**PREVOST**ENREGISTRÉ - REGISTERED
ISO 9001 & ISO 14001**MAINTENANCE
INFORMATION**

MI12-40

DATE :	OCTOBER 2012	SECTION :	06 - Electrical
SUBJECT :	LOAD DUMP PROTECTION 50DN ALTERNATOR

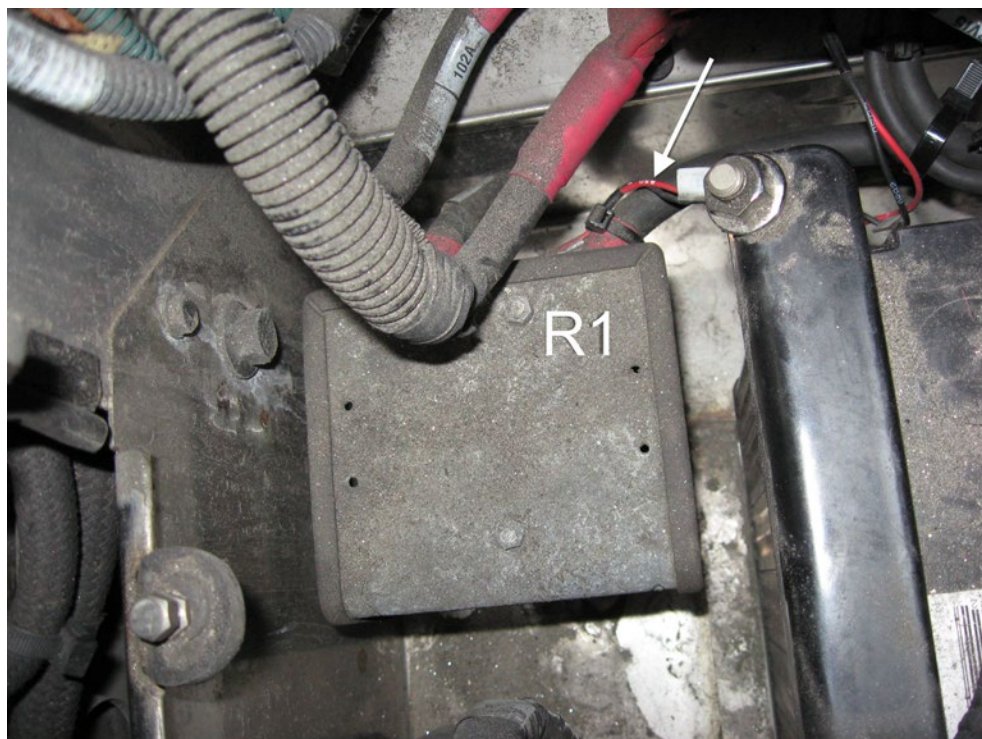
1. Open breakers CB1 & CB2

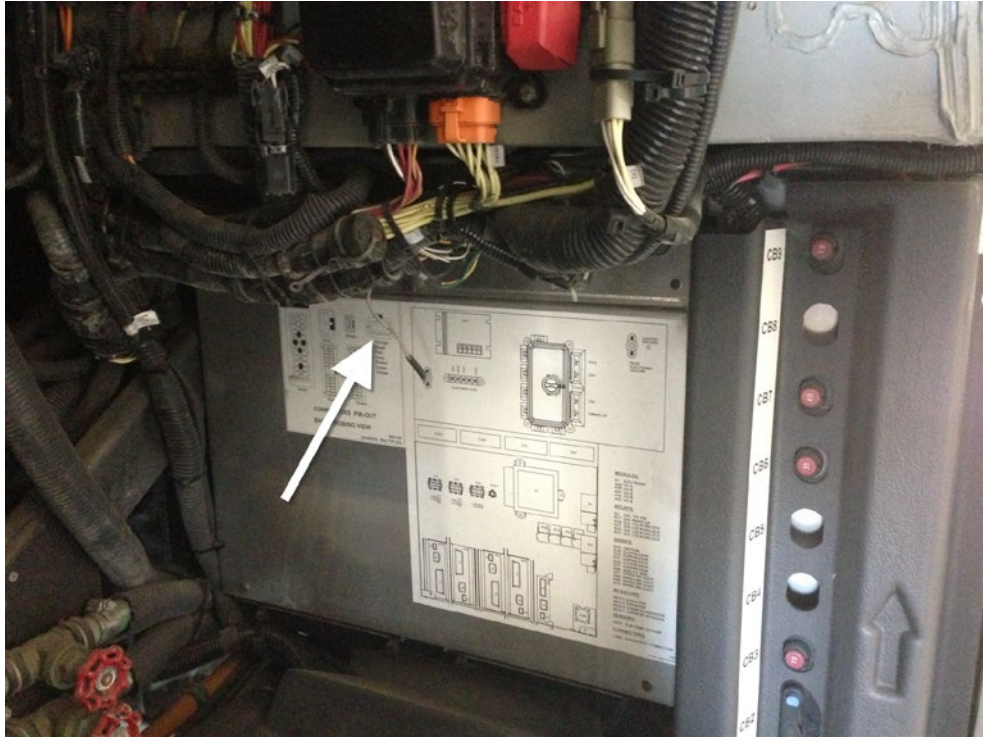
2. Open the battery box cover.
3. Locate wire 24-85G-18 running from R1 relay.

4. Locate SP17, gray spare wire near connector C21.

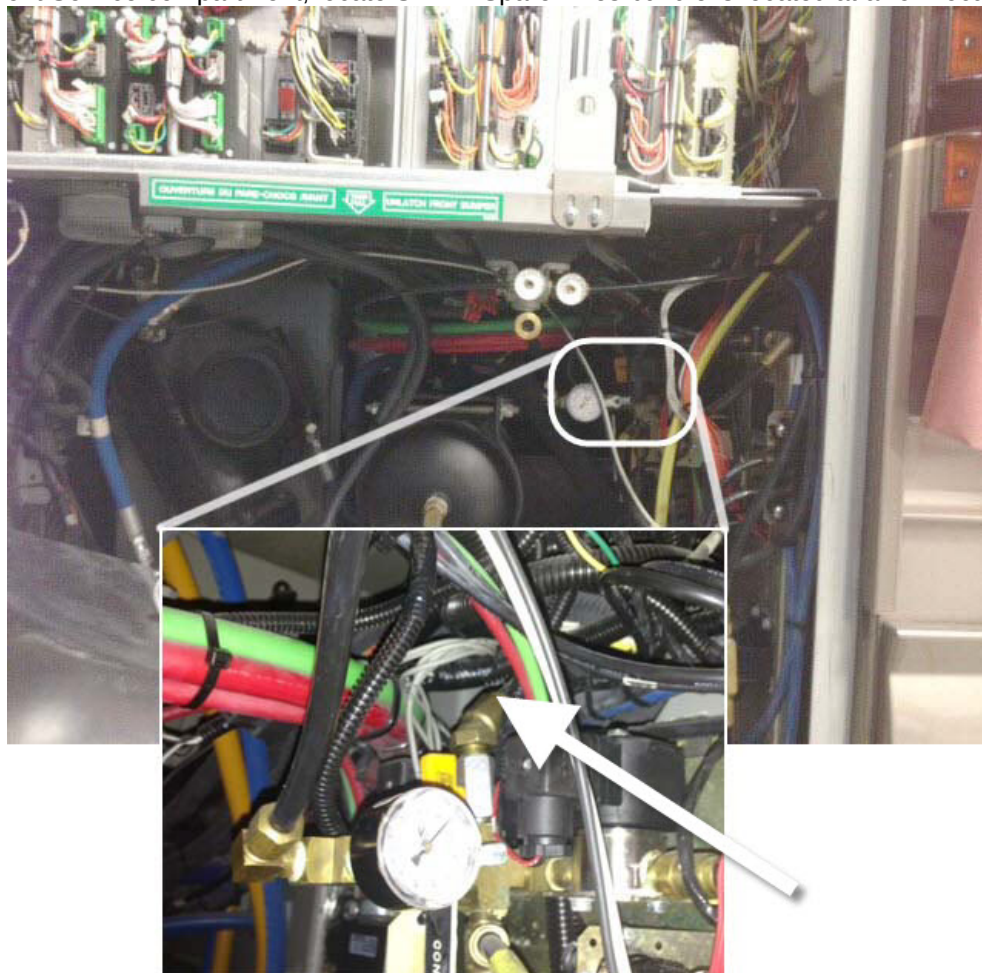
5. At R1 relay, disconnect 85G and cut ring terminal.
6. From pin 86 of R1 relay, run a new 85J red 18ga wire up to SP17.
7. Splice 85J to SP17 using #562228 butt splice and heat shrink tube #562499.
8. Crimp a #560082 ring terminal on 85J, relay side.
9. On existing wire 85G, solder a new diode #561740. Weld and splice other end on wire 85J. Label D62. Protect with translucent heat shrink #562499.

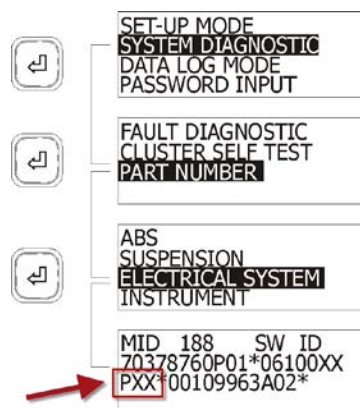
10. In front Service compartment, locate SP17. Spare wires bundle is located at arrow location.

11. Splice a new 85J red 18ga wire on SP17 using #562228 butt splice and heat shrink tube #562499.
12. Connect other end of 85J to JA14 on A36 module. Crimp terminal #562771 with crimper #683765.
13. In the Message Center Display (MCD), verify multiplex software version. (Version should be P17 and later)
14. Follow this menu sequence to verify the software version of the multiplex system.
15. If version is P16 or earlier, reprogram the multiplex to the latest version.
